**SERVICE BULLETIN**

103

INSPECTION OF OUTBOARD ELEVATOR HINGE PIVOT BUSH

FIG 1  
SECTION THROUGH PORT ELEVATOR  
OUTBOARD PIVOT LOOKING FORWARD

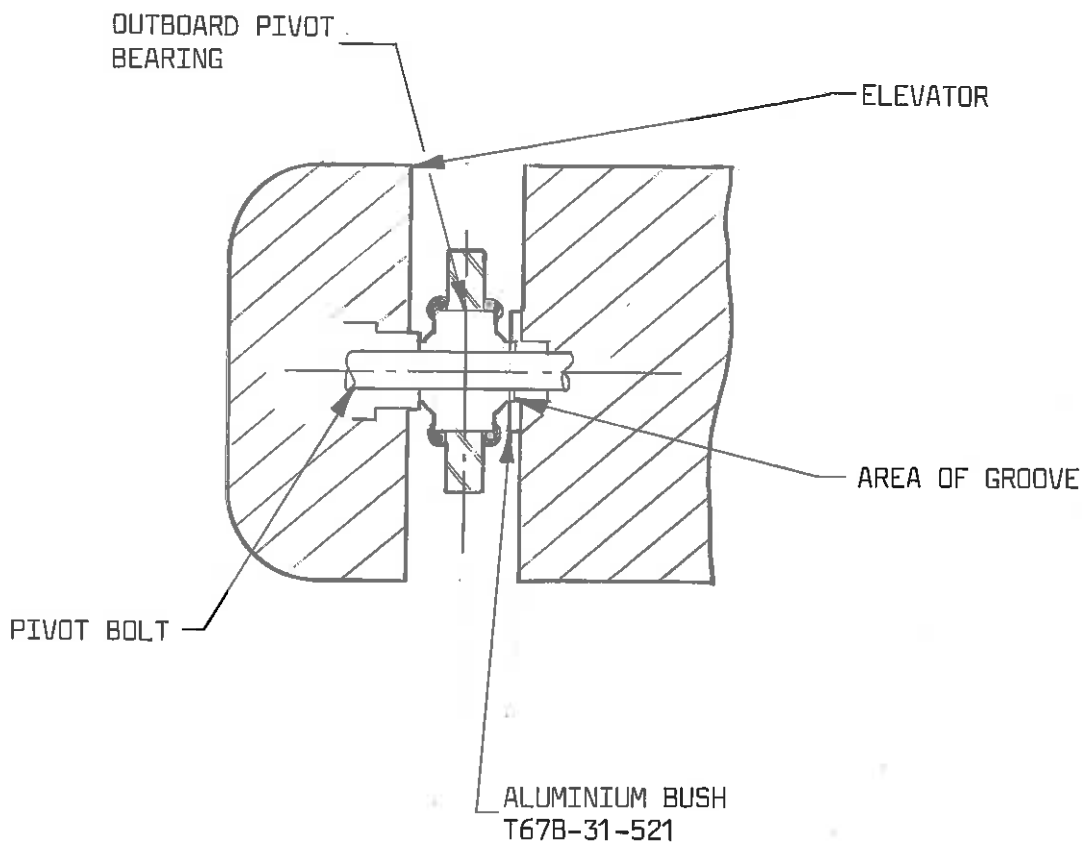
A case has been reported whereby, upon removing the port elevator, a "washer" was found at the outboard pivot. When investigated further it was established that the washer had been the head of the pivot bush which had been worn by the pivot bearing.

1. Remove port and starboard elevators.
2. Inspect pivot bush for loose head, ref Fig. 1.
3.
  - i) If loose head found, invoke Mod M710 Phosphor Bronze Bush in Lieu of Aluminium Bush at or before next 50 flying hour check.
  - ii) If groove is worn to a depth of greater than 0.5mm then invoke Mod M710 at or before next 150 flying hour check or 100 flying hour check as applicable.
  - iii) If groove is worn to a depth of .5mm or less then invoke M710 at next 12 month check (annual).
4. When refitting pivot bolt torque load to 3.4 Nm (30 lb in).
5. On completion of inspection, annotate Log Book "SB 103 complied with".
